**BARN AT MONTROSE, HENTON, WELLS**

PROPOSED ANNEXE  
 1:500 BLOCK PLAN

0812
121A

**BLOCK PLAN 1:500**

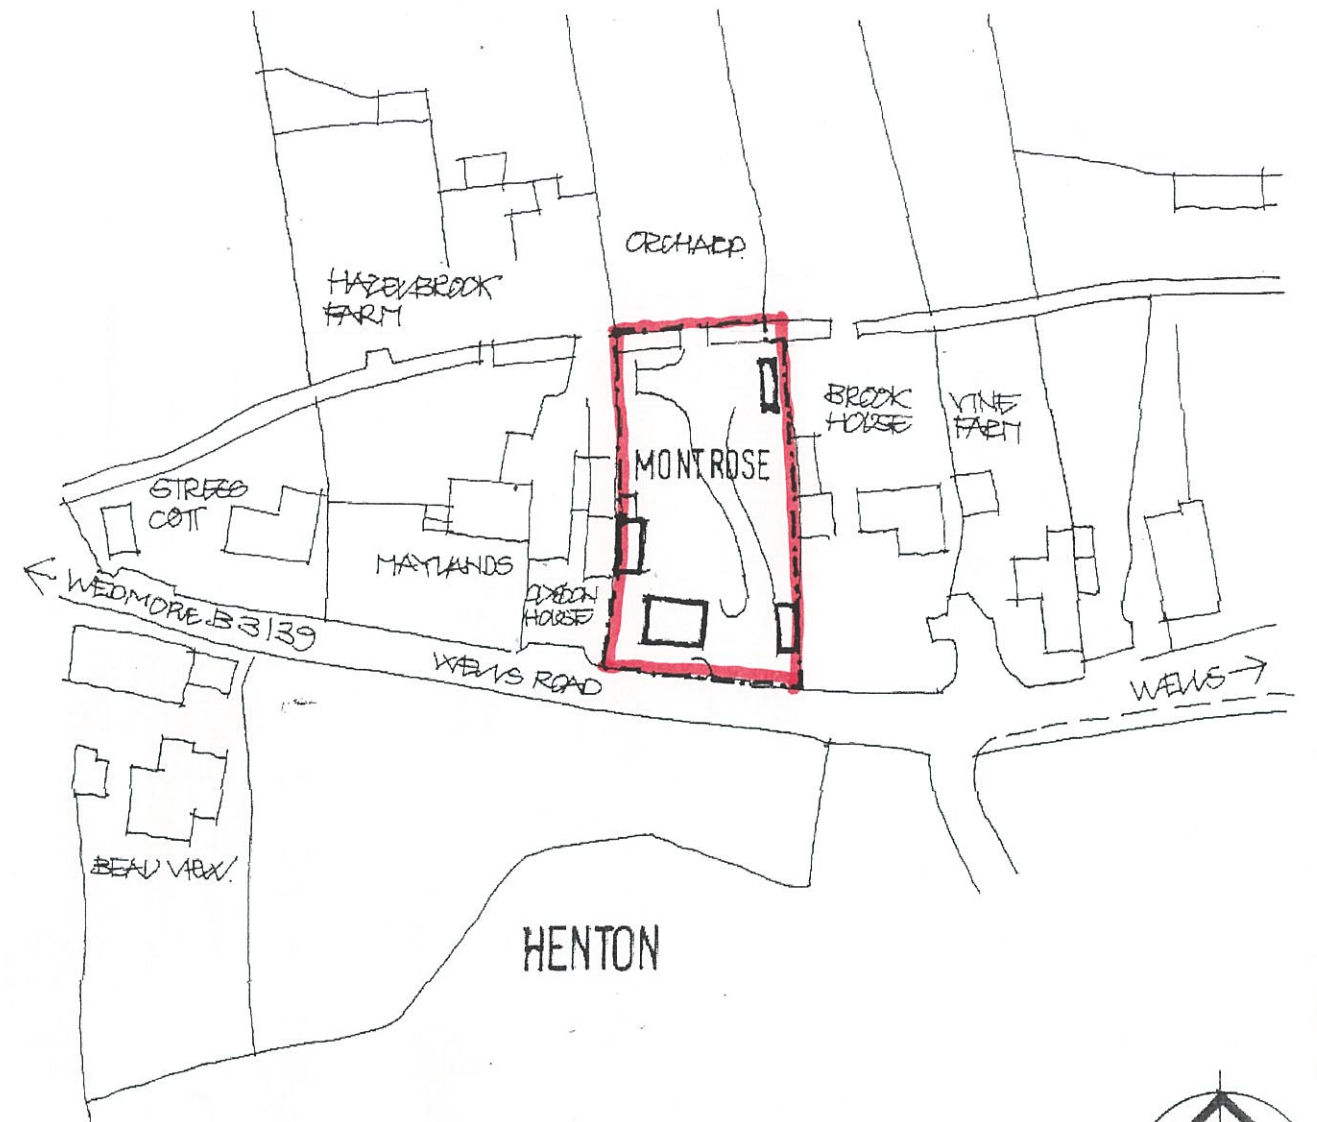
REVISIONS  
 'A' 10/16 HALL: ODD TO EXTERIOR TIMBER SIDE PANELS OMITTED  
 BEDROOM: SINCE ROOFLIGHT IN VIEW OF TUDOR NORTH EAVES, WINDOW SPAYED INTERNALLY & RAISED 100MM, WIDENED 100MM TO COMPENSATE FOR OMITTING ROOFLIGHT.
